**STAFF REVIEW AND RECOMMENDATIONS  
PUBLIC HEARING  
MAY 18, 2016**

PRELIMINARY PLAT: CEDARWOOD ADD 1 L/7A & 7B  
LEGAL DESCRIPTION: SEC 20, T18N, R1E S.M., AK  
PETITIONER: WASILLA-FISHHOOK INVESTMENTS, LTD  
SURVEYOR/ENGINEER: ACUTEK GEOMATICS/HOLLER ENGINEERING  
ACRES: 11.9 PARCELS: 2  
REVIEWED BY: PEGGY HORTON CASE: 2016-054

The request is to divide Lot 7, Cedarwood Addition #1, Plat #2012-90 into two lots to be known as Lots 7A & 7B, Cedarwood Addition #1, containing 11.9 acres. Located within NW¼ SW¼ Section 20, Township 18 North, Range 1 East, Seward Meridian, Alaska, lying east of N. Sorrelwood Drive.

**EXHIBIT C-8**

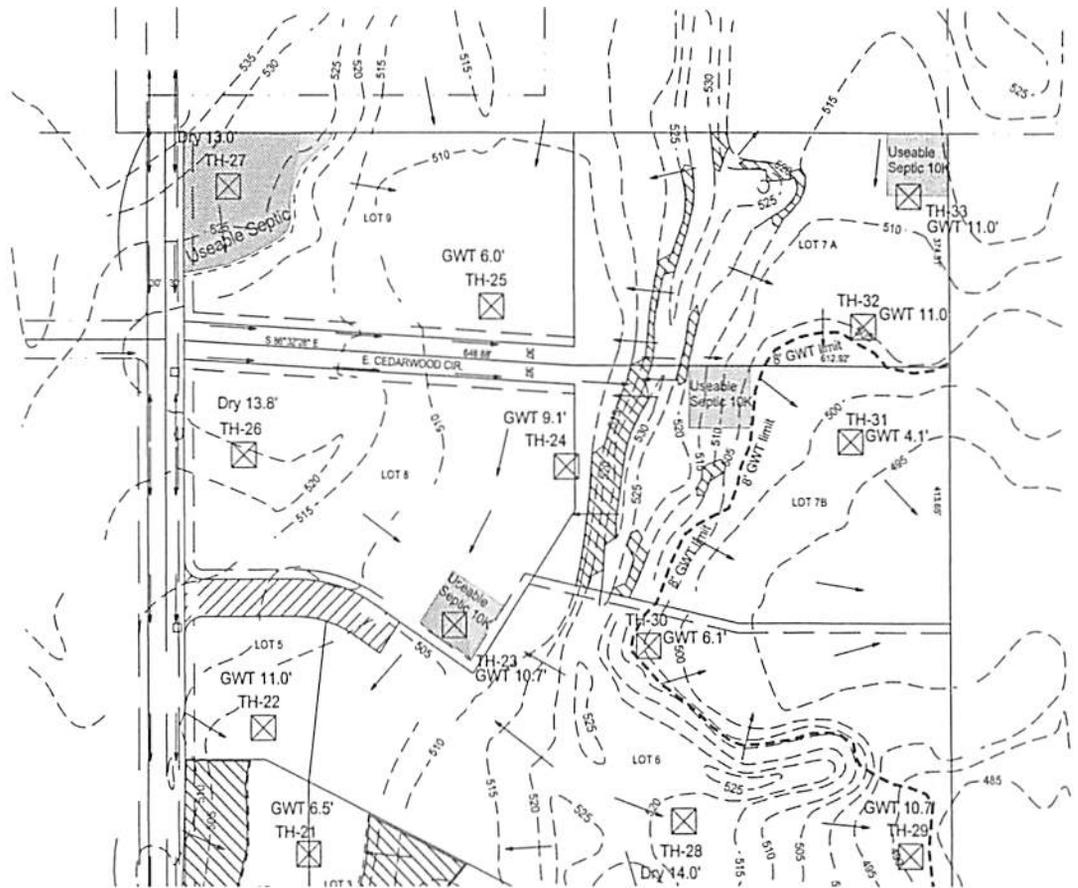
**Drainage:** Although there is no road construction with this subdivision, Mr. Holler provided drainage arrows to show drainage along the existing roads and general drainage patterns in the area (**Exhibit C-2**)
